**TECHNICAL BULLETIN NUMBER 005-2009**

**MODEL: Stelvio 1200 NTX**

**SUBJECT: Wheels and knobbly tyres**

Piaggio & C. SpA

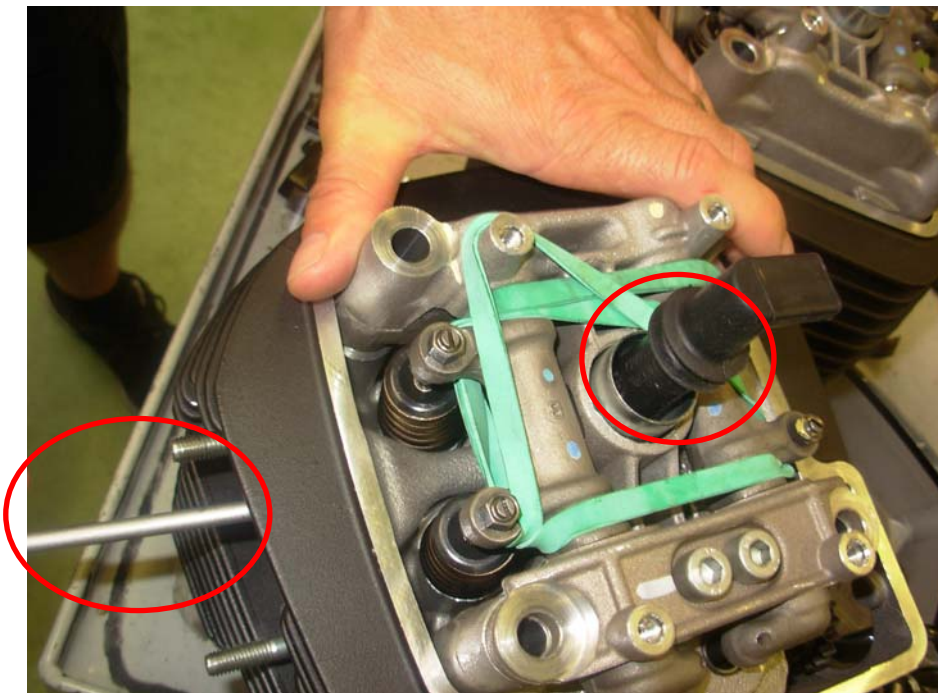
As shown in the photo, insert a normal flat headed screwdriver into the drain hole in the spark plug well on the head, on either the intake side or exhaust side. Apply leverage, pushing down on the screwdriver, to lift the boot. This procedure significantly simplifies the removal of the spark plug boot and preventing damage to the boot itself, which is not reimbursable under warranty.

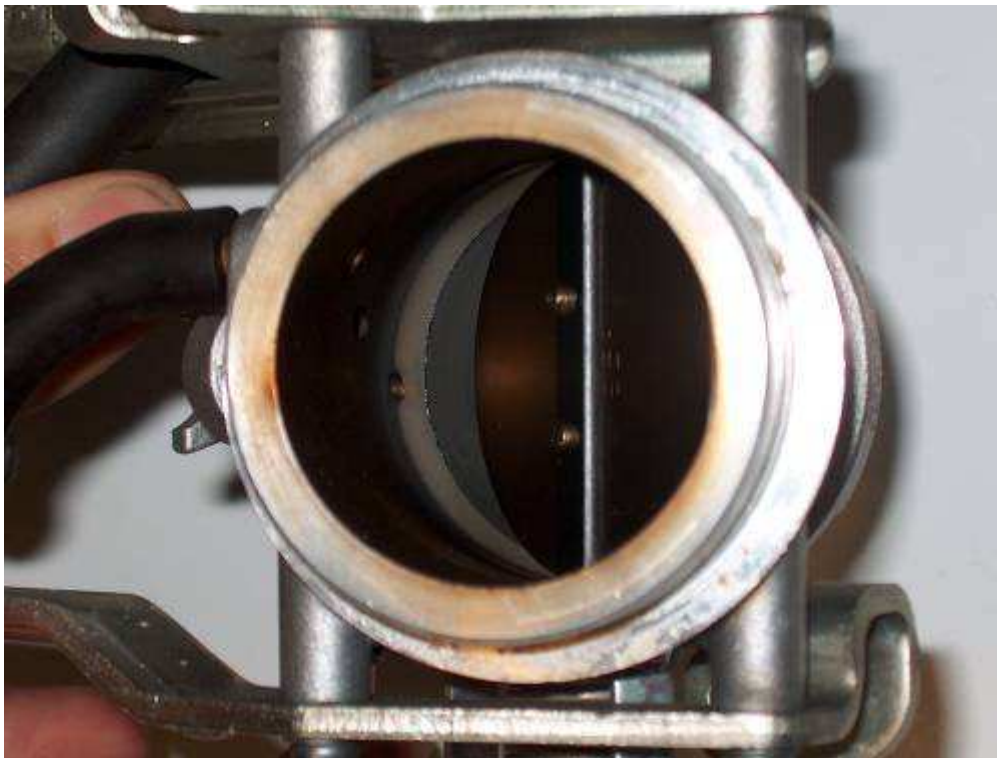
The following image shows significant deposits of unburnt fuel residue in the air duct: with the throttle closed, these deposits impede the injection system from delivering the correct air fuel mixture, compromising engine function at idle or at throttle lift-off and causing engine cut-out or irregular idling.

The throttle body must be cleaned with specific products for cleaning throttle bodies or carburetors.

Proceed as follows: with the throttle valve fully open, clean the duct with a normal cloth - do not use brushes or rotary brush attachments; never remove the throttle valves from the body.

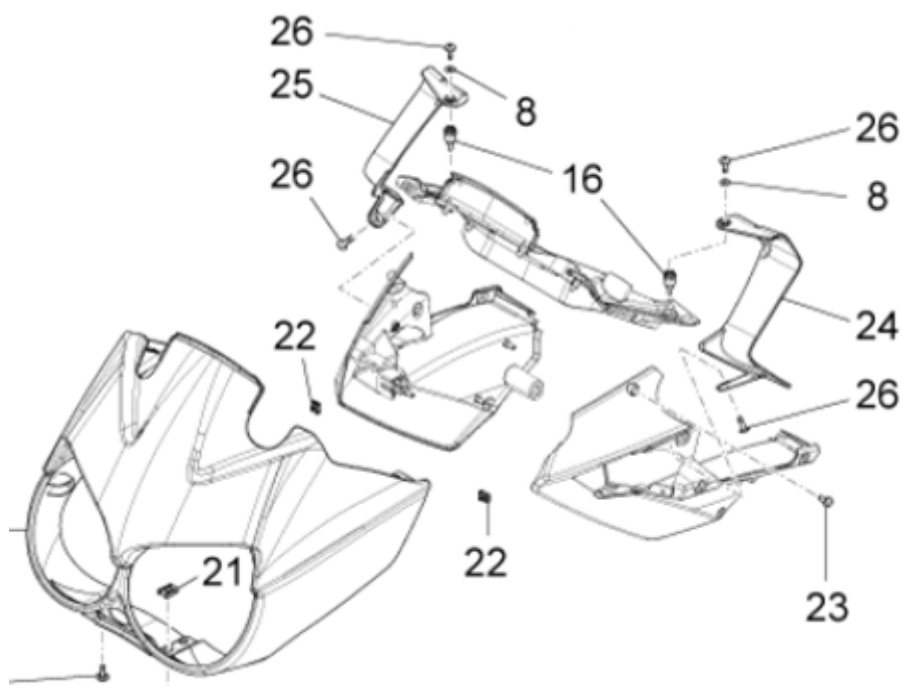
as part of our research aimed at improving the characteristics of use of our products, we deemed it necessary to **remove the left and right air deflector dust guards (code AP8120622)** the first time that the vehicle is brought to our workshop.

The item to be removed is indicated as No. 8 in spare parts catalogue:

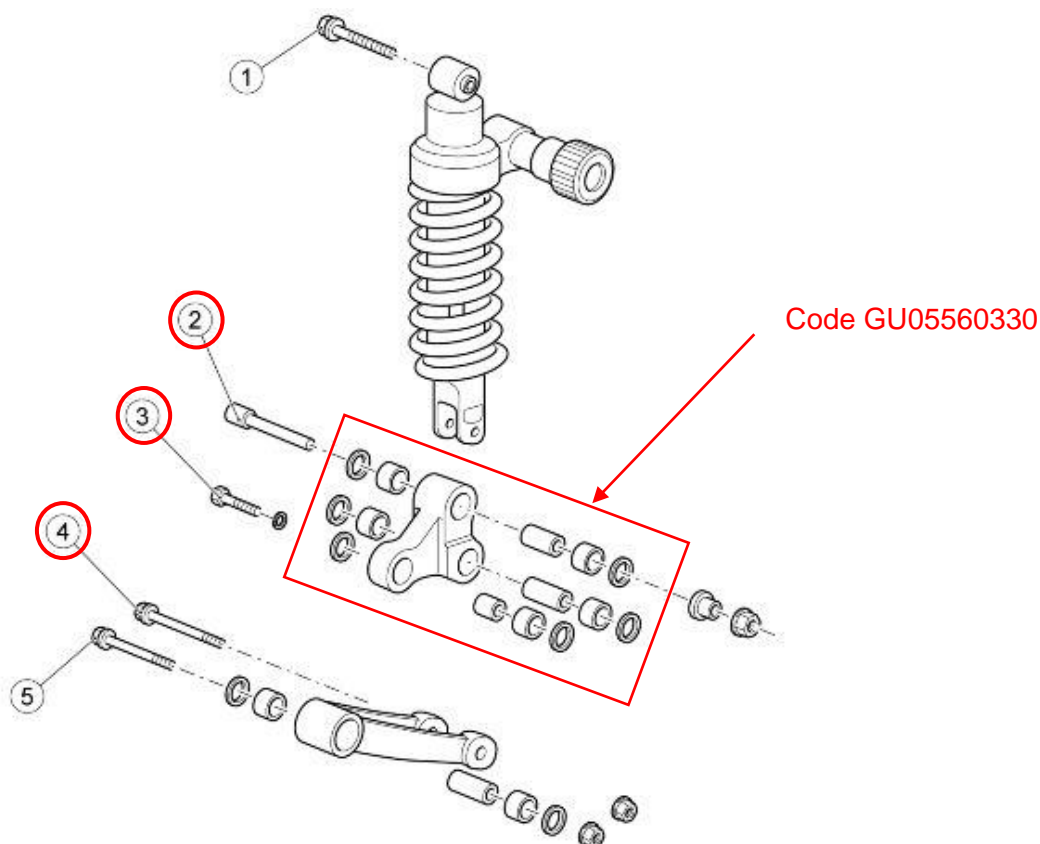
- After putting in the vehicle in safety by securing it in adequate manner, lift it so as to completely take the weight off the rear wheel of the vehicle

- Replace the rear suspension double connecting rod as shown in the workshop manual in the Chapter "Suspension - Shock absorber sect.", an extract of which is provided below.

pos.	Description	Type	Qty	Torque
2	TCEI screws for fixing double connecting rod/swingarm	M10x82	1	50 Nm (36.88 lb ft)
3	TE screw for fixing double connecting rod/shock absorber	M10x47	1	40 Nm (29.50 lb ft)
4	TE flang. screws for fixing single connecting rod/double connecting rod	M10x95	1	50 Nm (36.88 lb ft)

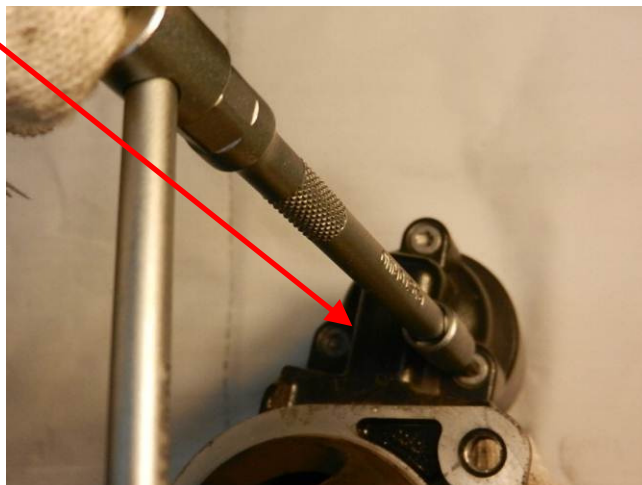
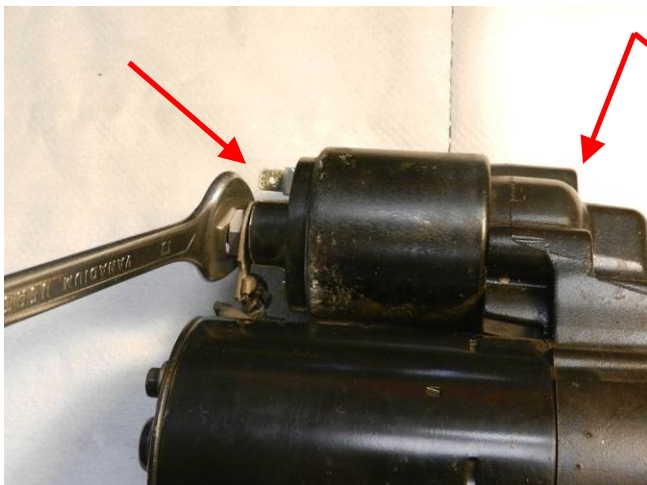
- Starter motor very dirty in flywheel engagement area

dirt

- Undo the nuts fastening the solenoid and remove the solenoid

- Disassemble the starter motor

- Clean the mechanisms with WD40-P140 degreaser for mechanical systems and lubricate with AGIP GREASE MU2

- Clean the armature, solenoid and fork

- Refit the solenoid, fork and rubber block

- Align the holes in the ring

- Refit the motor housing and the solenoid

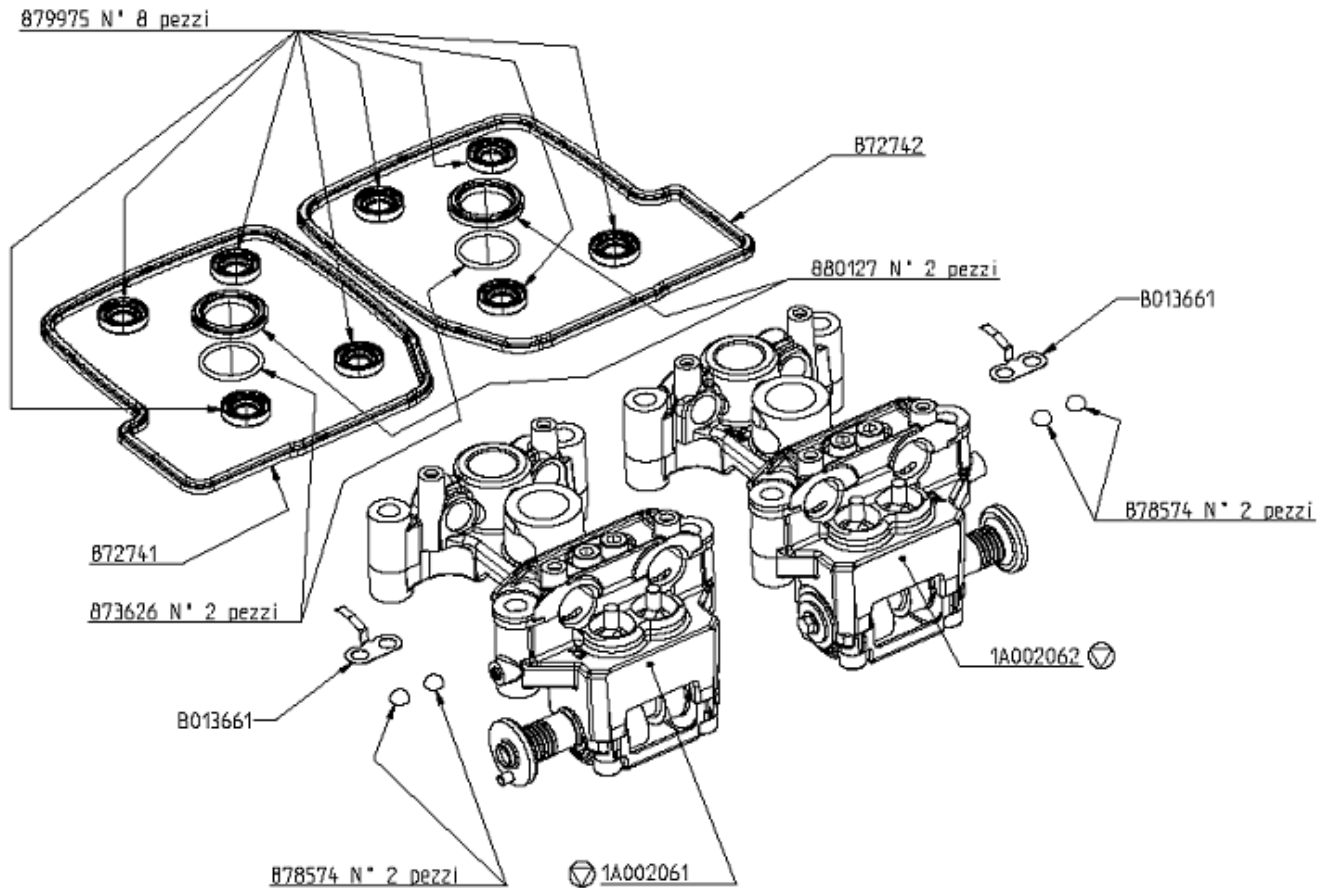
To verify whether the vehicle can be modified with **kit A** remove the timing cover and check whether it is the floating type, which can be recognised by the presence of the circlip in the spark plug hole area:

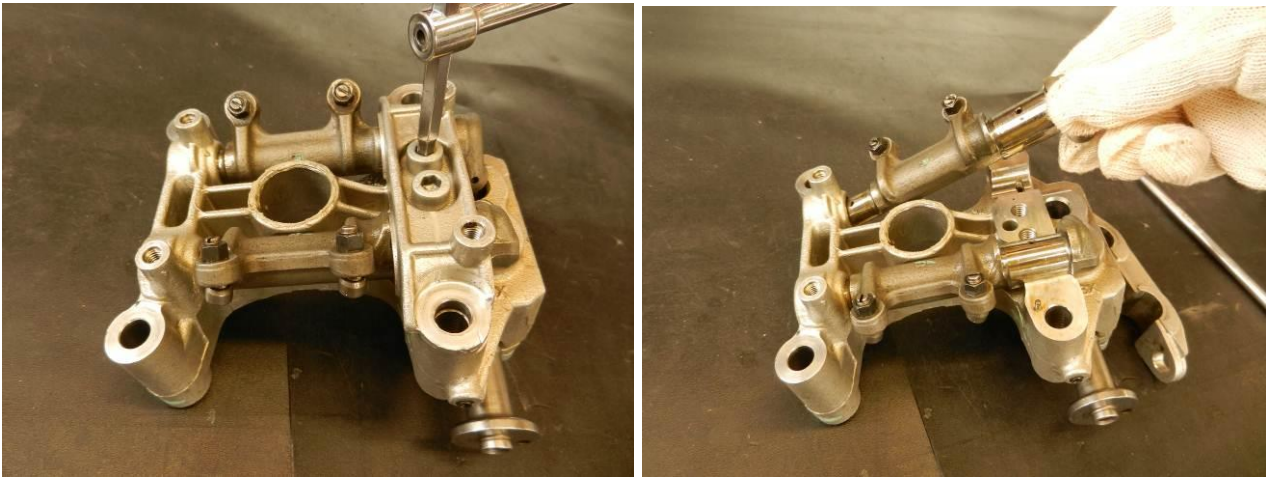
As per Workshop Manual procedure, access the timing system by removing the cylinder head cover, paying attention to the internal gaskets; remove the timing gear from the camshaft and then remove the timing system cam tower.

Remove the rockers mount and delicately slide them from their seat.

**P/N 878524**

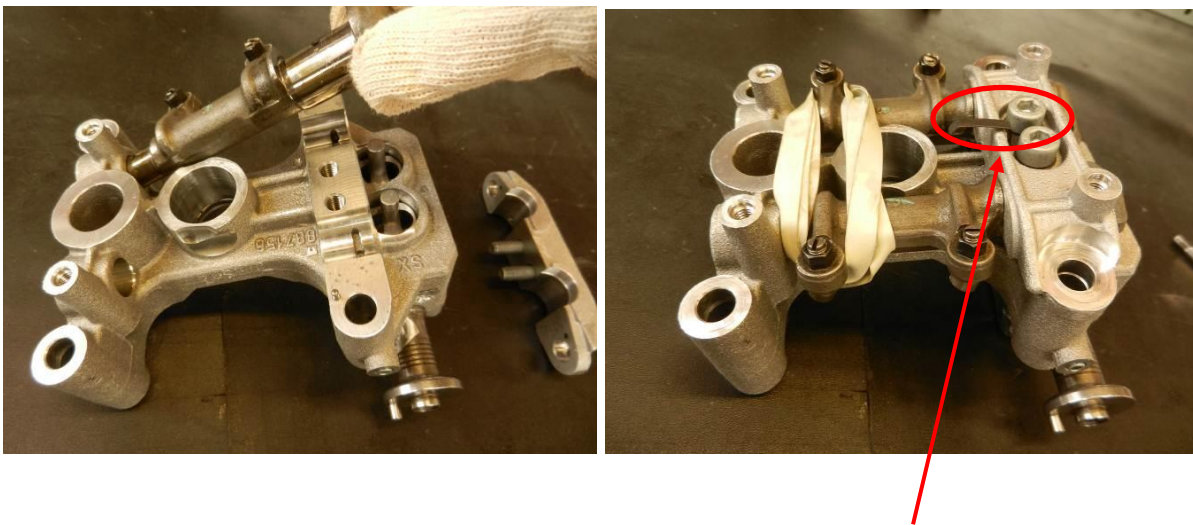
Place the pads P/N 878524 in the relative seats with the aid of a layer of grease so that they hold the position.

Fit the old rockers in the **new** cam tower, fasten the rocker retainer cap, installing the **new** ground plate **part No. B013661** between the retainer cap and the fastener screws (tightening torque 18 Nm);

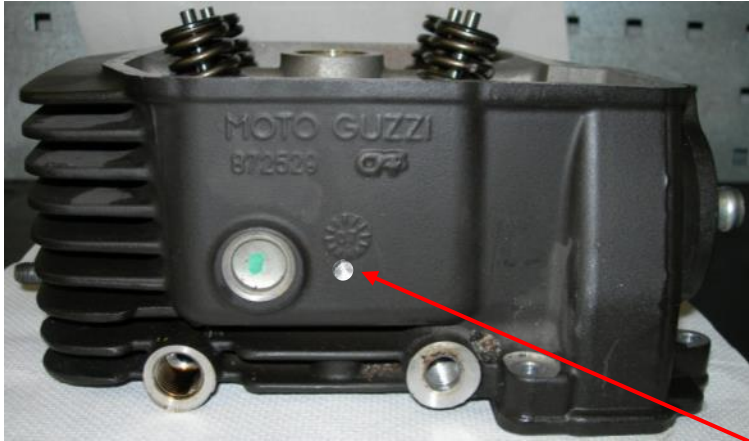
To determine if the vehicle may be modified with **kit B or C**, remove the timing cover and check that it is a **NON**-floating type cover, which is identifiable by the absence of a circlip in the spark plug hole area:

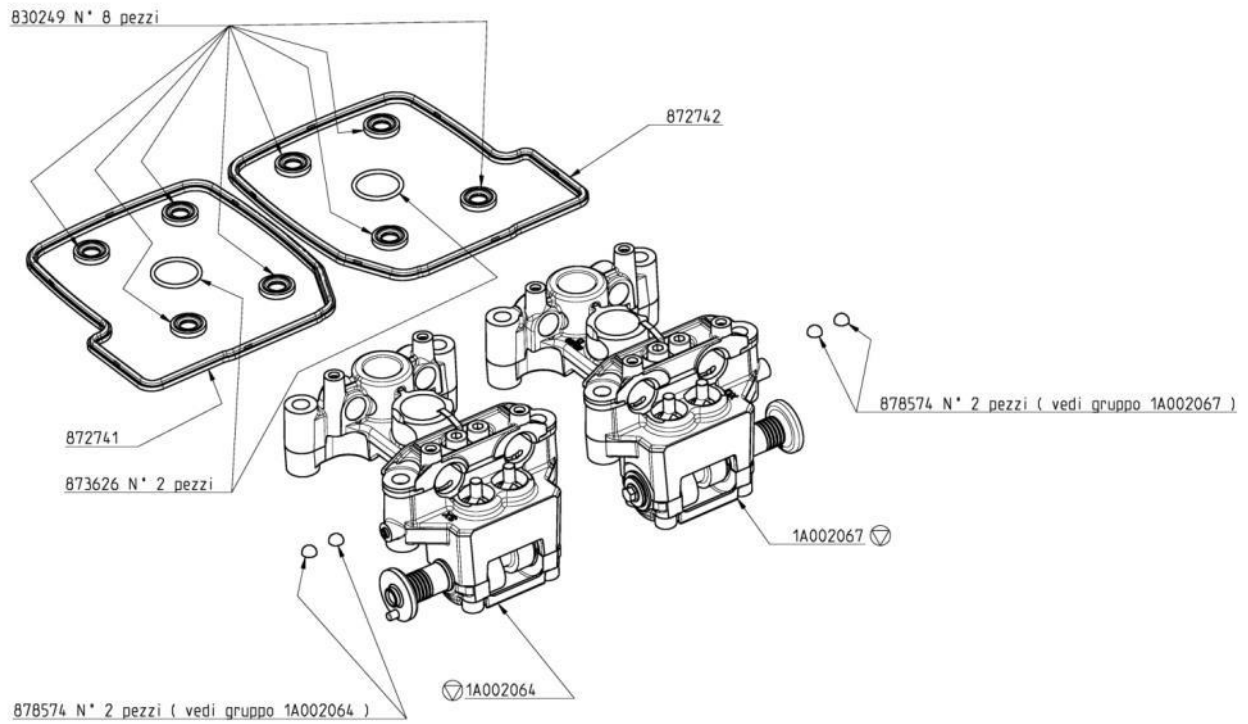
Then check the following:

If the marking is present, use **KIT B**

If there is no marking, use **KIT C**

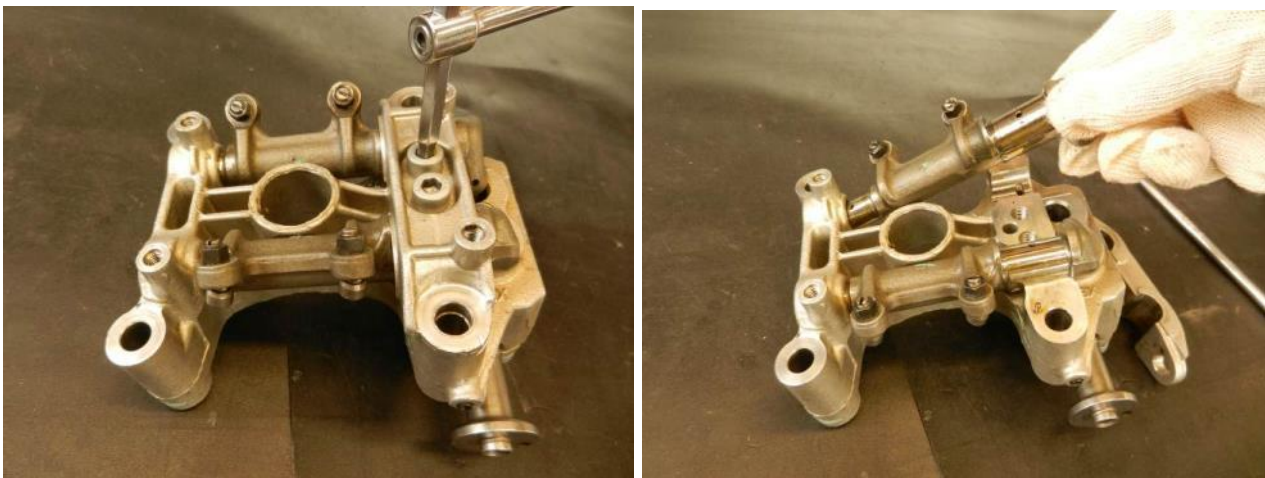
As per Workshop Manual procedure, access the timing system by removing the cylinder head cover, paying attention to the internal gaskets; remove the timing gear from the camshaft and then remove the timing system cam tower.

Remove the rockers mount and delicately slide them from their seat.

**P/N 878574**

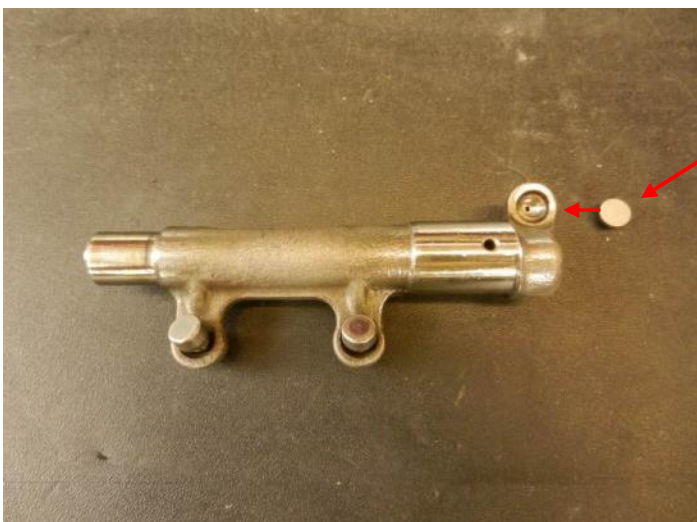
Place the pads P/N 878574 in the relative seats with the aid of a layer of grease so that they hold the position.

**P/N B013661**

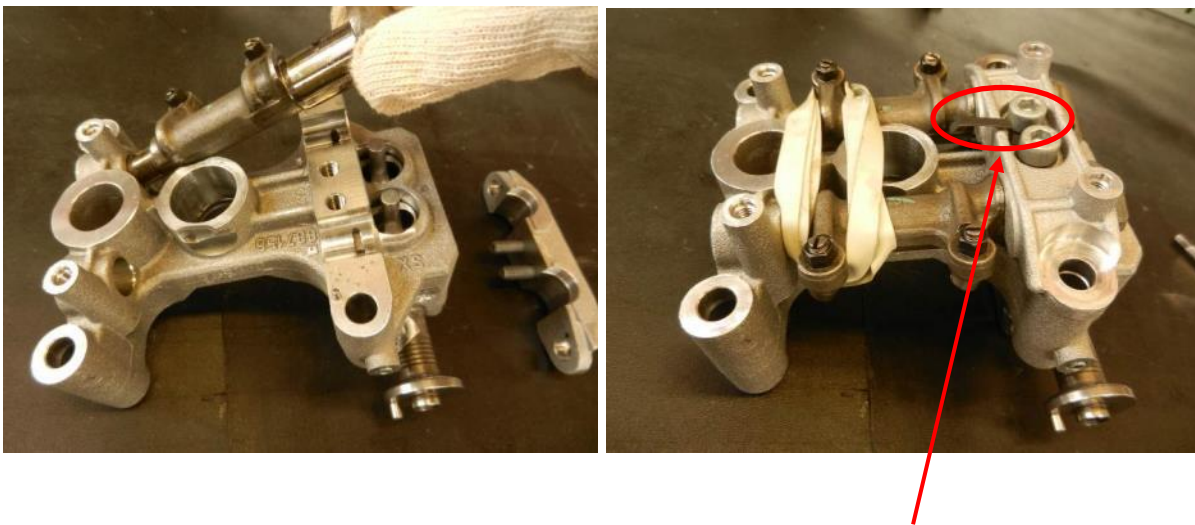
Fit the old rockers in the **new** cam tower. Fasten the rocker retainer, remembering to fit the **new** ground plate **P/N B013661** included in the kit between the cam tower and the fastener screws (tightening torque 18 Nm), discarding the old ground plate.

Note: in order to ensure that the rockers stay in their seat, bind the rockers temporarily with an elastic band
